NEWTOWN TO CITY
TRANSITIONAL CYCLEWAY
90% DETAILED DESIGN ROAD SAFETY AUDIT
PREPARED FOR WELLINGTON CITY COUNCIL
March 2022

Newtown to City Transitional Cycleway 90% Detailed Design Road Safety Audit

Figure 2-17: Cambridge Tce turning pockets for cyclists

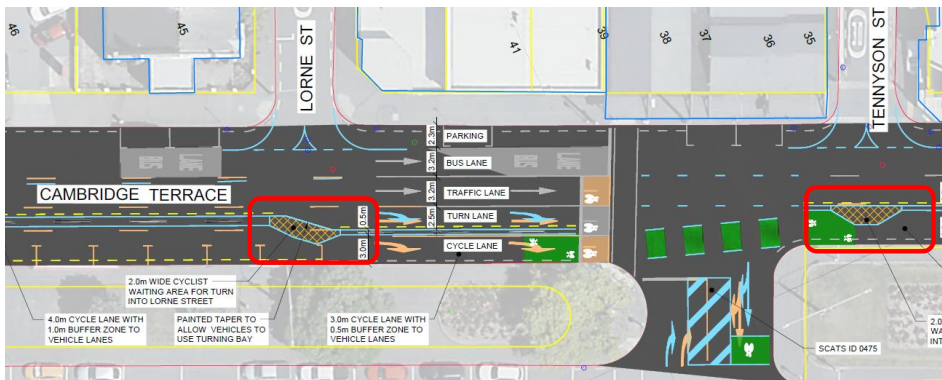
The design details a hatched zone for the provision of the turn movement into, and out of Lorne Street. This design narrows the cycle markings for the through movement at this location and occurs at the development of the right turn lane.

A similar feature is provided at the Tennyson Street intersection, as detailed in Figure 2-17 below.

The hatched zone will be required to accommodate cyclists who not only turn in, but also turn out of Lorne Street and Tennyson Street. The SAT are of the opinion that the marked space is insufficient to allow cyclists to safely depart from the through movement, or wait safely to join the through movement, without their wheel being exposed to passing traffic. This waiting space impedes on the safe movement of cyclists along the bi-directional facility. The SAT acknowledge that the cycle turn volume at these locations may be low, however the risk remains.

Designer response	As per response to 2.4.3 this issue has been identified and alternate markings will be developed for 100% designs. Care will need to be taken to not mix the markings up with hook turn markings which are appropriate for a certain function at an intersection.
Safety Engineer comment	Agree with Designer.
Client decision	Agree with above
Action taken	No action required

Figure 2-20: Cycle hook turn box located within intersection

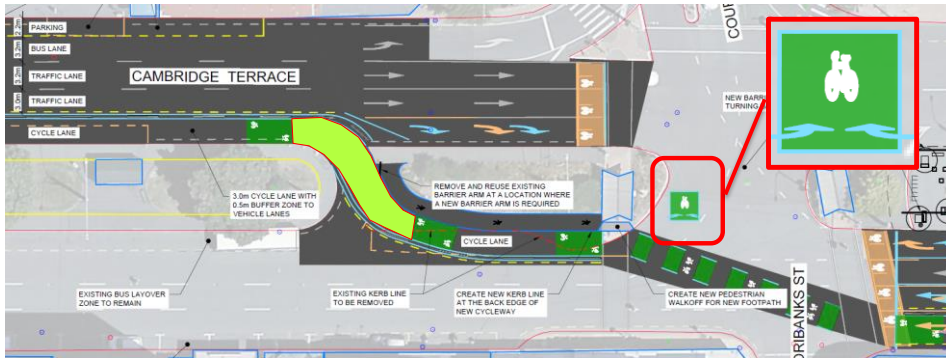
The design has a hook turn box positioned in the departure lane from Courtenay Place, as indicated in Figure 2-20 below.

Arrows within the box (see insert above) indicates that the hook turn box is to accommodate the right turn in / left turn in for cyclists into Courtenay Place.

The SAT have significant concerns that this hook turn movement appears to occur in the right hand out bound lane from Courtenay Place and is in direct conflict with this movement. As stated previously, traffic signal phase diagrams were not supplied for this project. The SAT consider that the hook turn box is not in a safe position given the complex movements observed at the intersection.

Frequency	Severity	Rating
Crashes are likely to be common	Death or serious injury is likely	The safety concern is significant
Designer response	Agree with concern raised by SAT with 90% design. Design to be updated to relocate hook turn and redefine turning paths from Courtenay Place. Working sketch below:

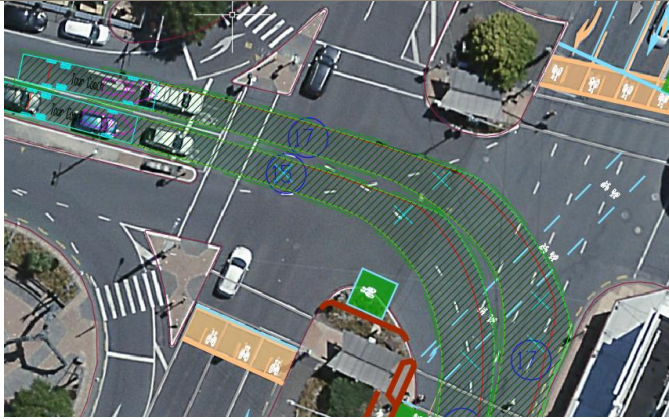
- ⌘ Cyclists could potentially use the existing footpath crossing (signalised) over Cambridge Terrace, however the shelter in the central median would significantly impact on safe movement and would cause conflicts between cyclist / pedestrians. This risk is present for both the north bound and southbound cycle movements wishing to access Courtenay Place.

- ⌘ Southbound cyclists wishing to access Courtenay Place would be required to cross the northbound through cycle movement. There are presently no design features to allow this to occur safely, avoiding head-to-head conflicts, of rear end type crashes if they pull left to wait and are exposed to traffic from behind.

Figure 3-1: Alternate cyclist linkage to/from Courtenay Place

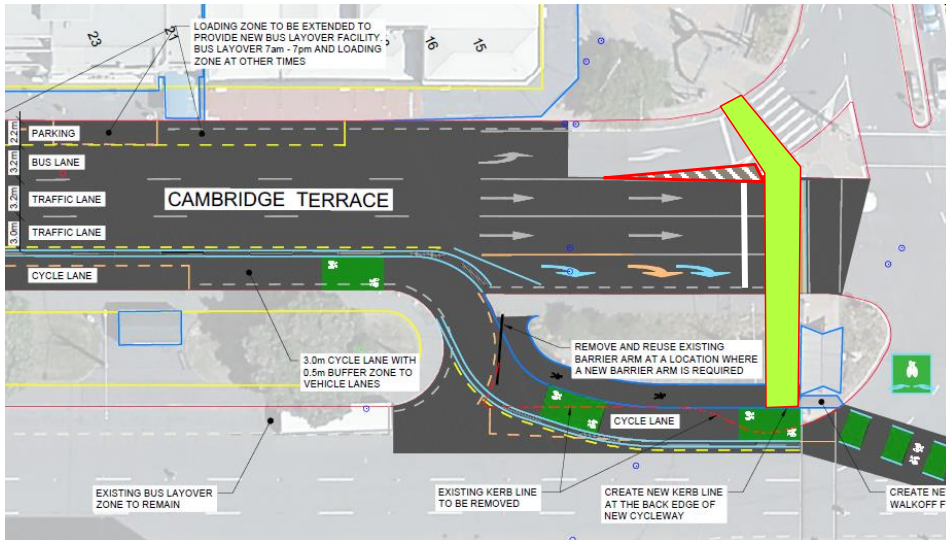
The current pedestrian crossing south of the intersection has a suitable level of service for pedestrians, however this would not be suitable to incorporate cyclists as part of the crossing movement on the current crossing point. Access to the existing path through the central median also occurs immediately adjacent to the lane shift of the new facility.

The SAT consider that there is a possible alternate linkage for cyclists from the new bi-directional facility, through the central island and across into Courtenay Place, running parallel with the current facility, as indicated in Figure 3-1 above.

This could be achieved through the formation of a new path through the central median, with porous pavers over the garden to maintain tree health. The limit line of the northbound movement can be moved back to facilitate the inclusion of a new crossing feature, ASB for through movements, and inclusion of a longer splitter island.

Figure 3-3: View of alternate cyclist connection utilising existing ASBs.

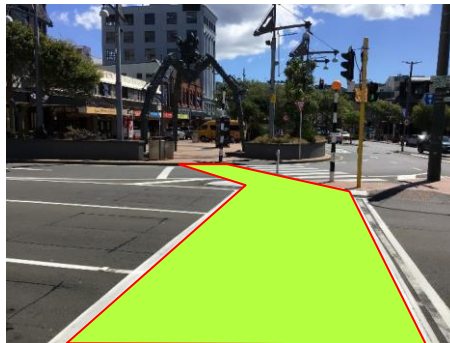
The formation of a shared path system at the connection to the cycle facility will facilitate the safe mixing of movements during peak periods.
